**FINAL DESIGN REVIEW
DATA PACKAGE
BEAM TUBE MODULE
DESIGN & QUALIFICATION TEST
CONTRACT C146**

**CBI TECHNICAL SERVICES COMPANY
PLAINFIELD, ILLINOIS
APRIL 11, 1994**

CBI CONTRACT 930212

SUBJECT QT STIFFENED END HEAD	CBI OFFICE NOE C		REVISION 1	REFERENCE NO. 930212
	MADE BY RJW	CHKD BY TKH	MADE BY RJW	CHKD BY TKH
	DATE 29MAR94	DATE 29MAR94	DATE 30MAR94	DATE 29 MARCH 94
	SHT ____ OF ____

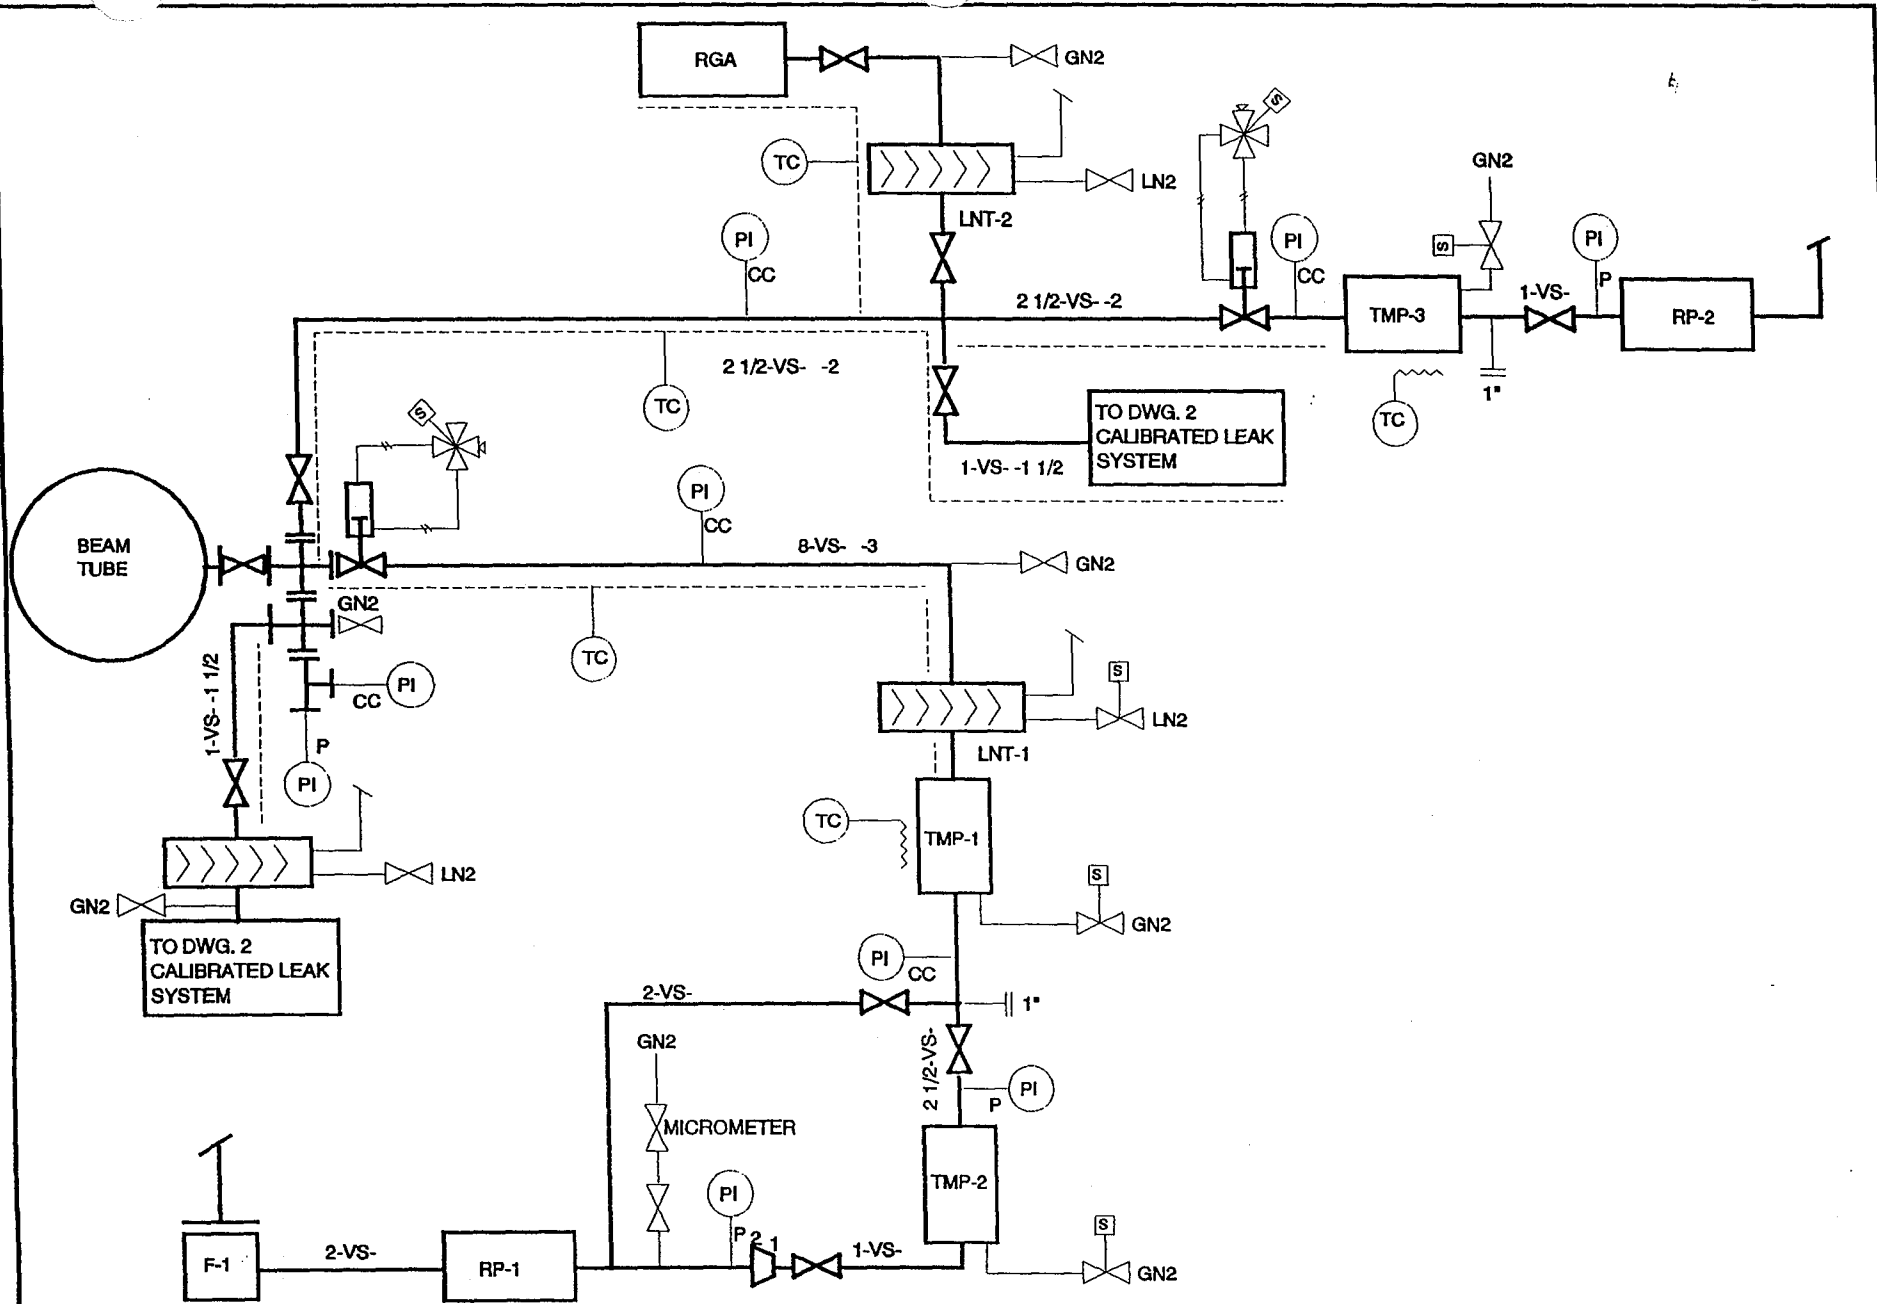
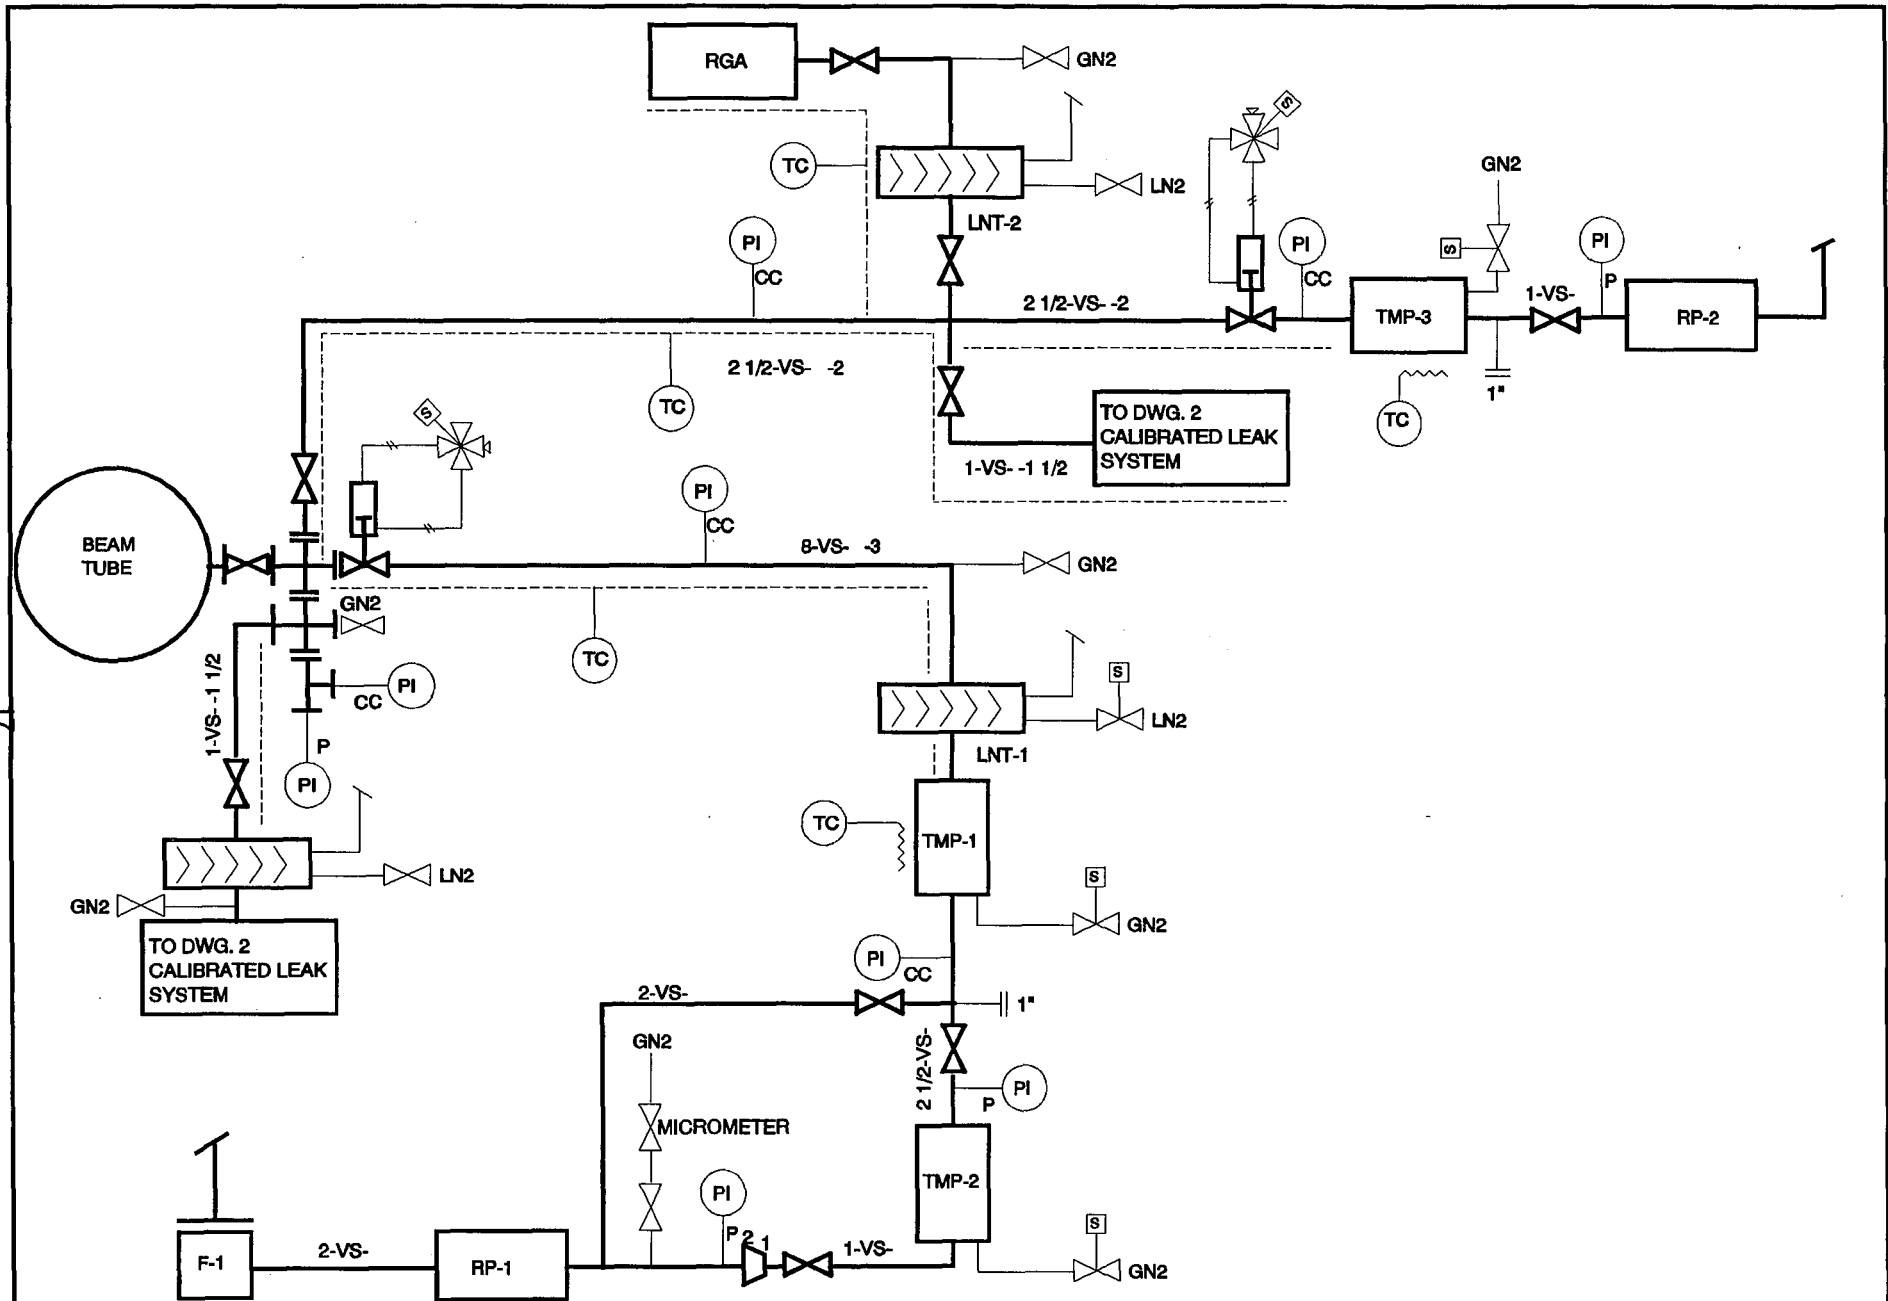
QT Stiffened end head: How is the weld to the tube to be made? The end could also become the feeder for the direct heating current if an additional short section of 48" tube is used for the current clamp as was done for the btd. This serves to give the correct spreading resistance as well as offer thermal isolation for the leads.
